**INTERDEPARTMENTAL COMMUNICATION**

**Subject:** Site Plan Special Permit #07/03/14 - #450 – Concord Public Schools – 37 Knox Trail

We have reviewed the plans titled “37 Knox Trail, Acton, Massachusetts” dated July 3, 2014 for the above mentioned special permit and have the following comments:

**Acton Ladder Truck**  
 feet  
 Width : 8.00  
 Track : 7.46  
 Lock to Lock Time : 6.00  
 Steering Angle : 45.0

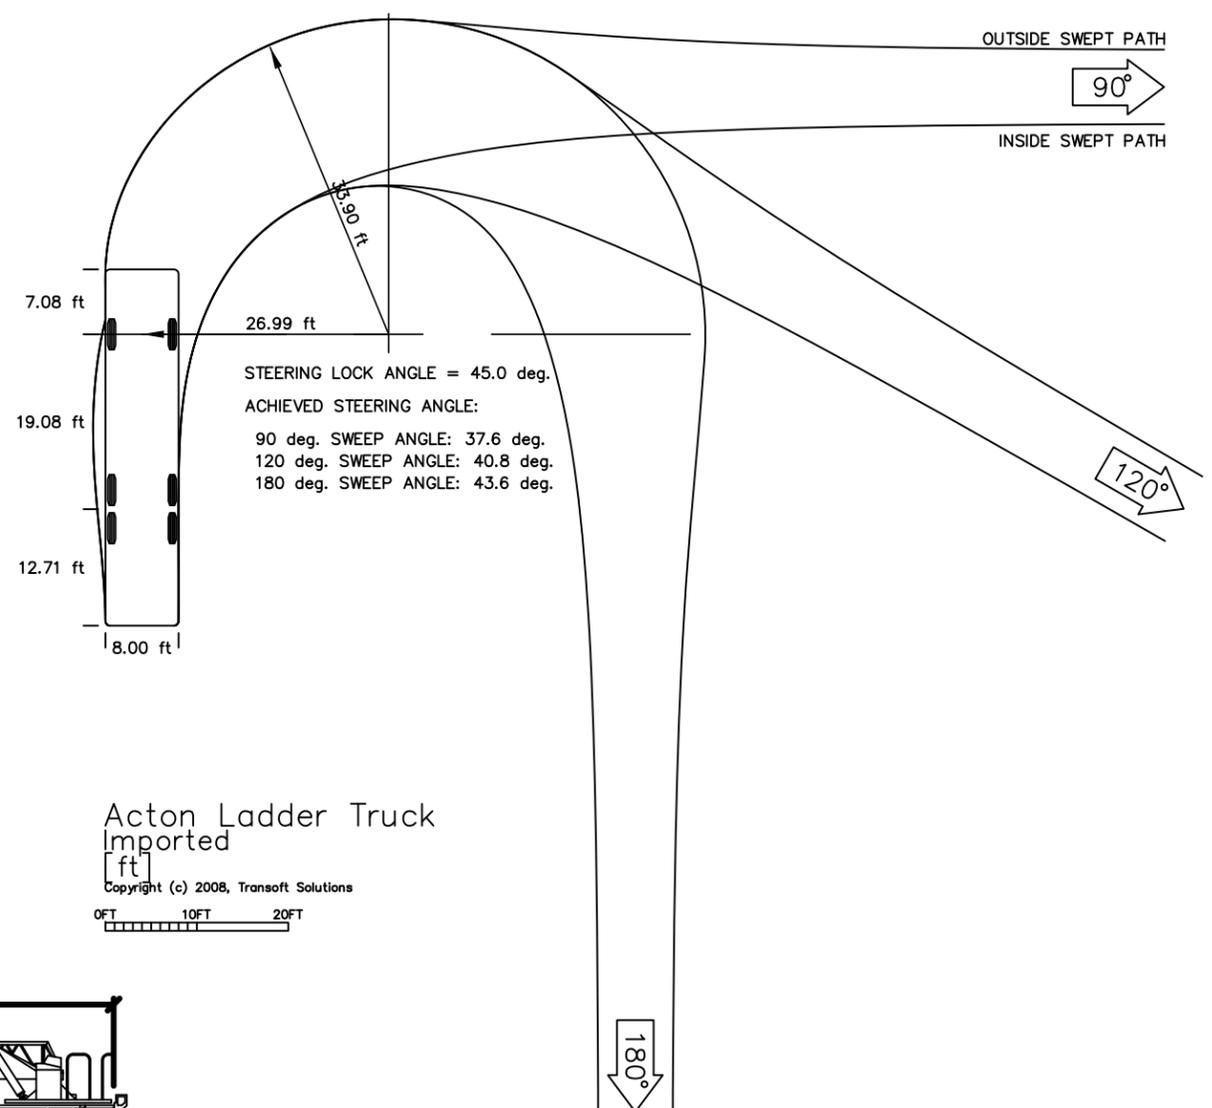
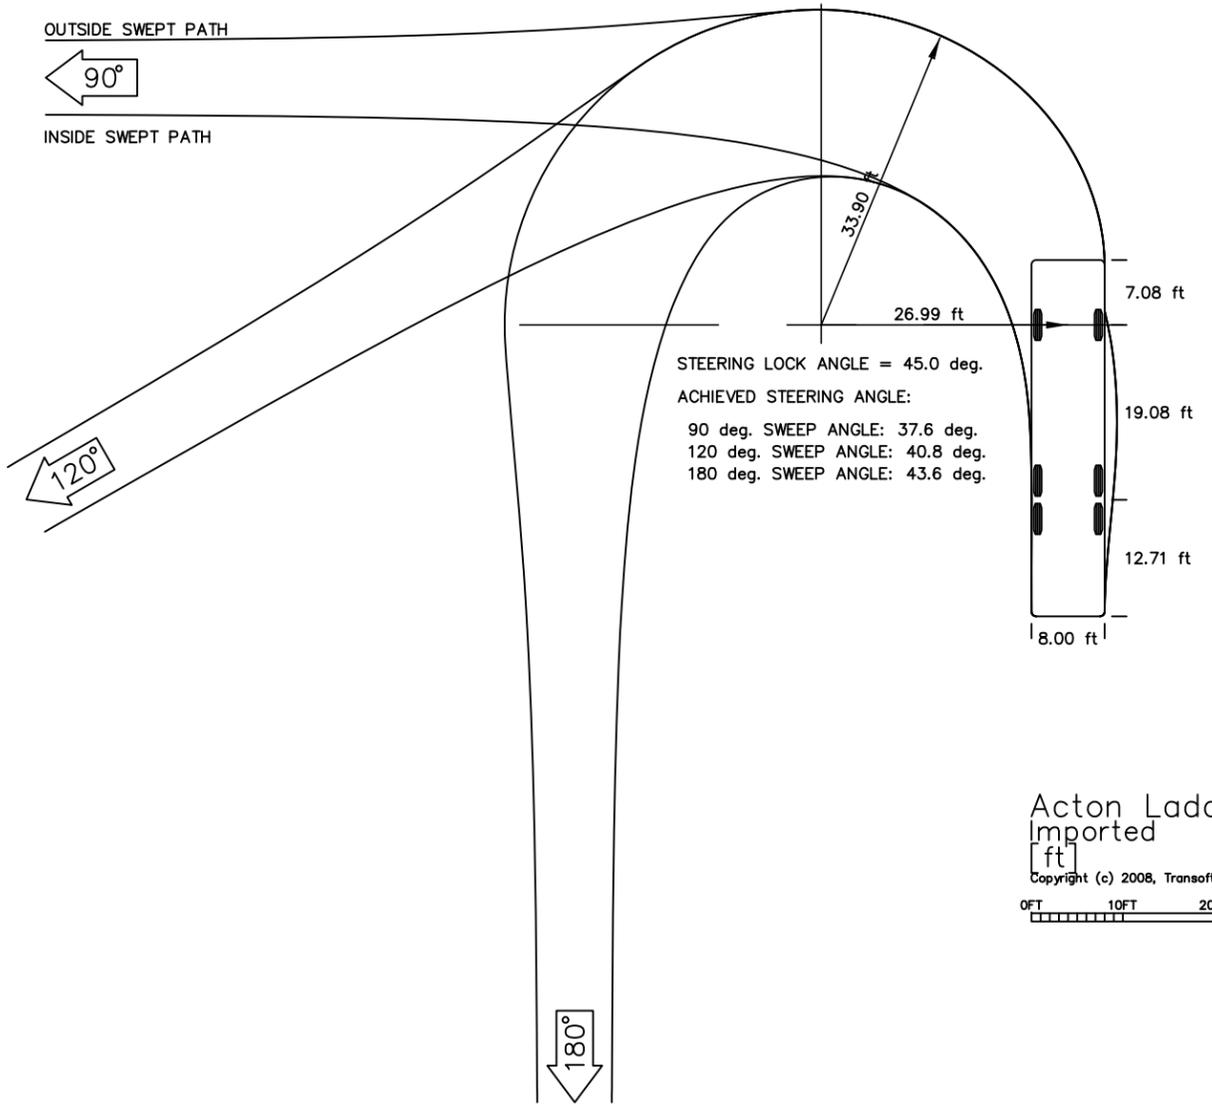
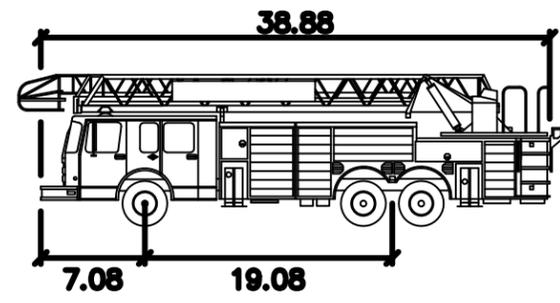
6. Based on our turning templates, an emergency SU-30 vehicle (fire truck) can maneuver within the site. Recently on another development the Fire Department has commented that the Acton ladder trucks are a different size than the SU-30 vehicle. Our office was given a copy of the ladder truck template by the applicant of the other development and we will supply that template with this memo. It appears the ladder truck would be able to maneuver within the parking area. We will defer further comment to the Fire Department.
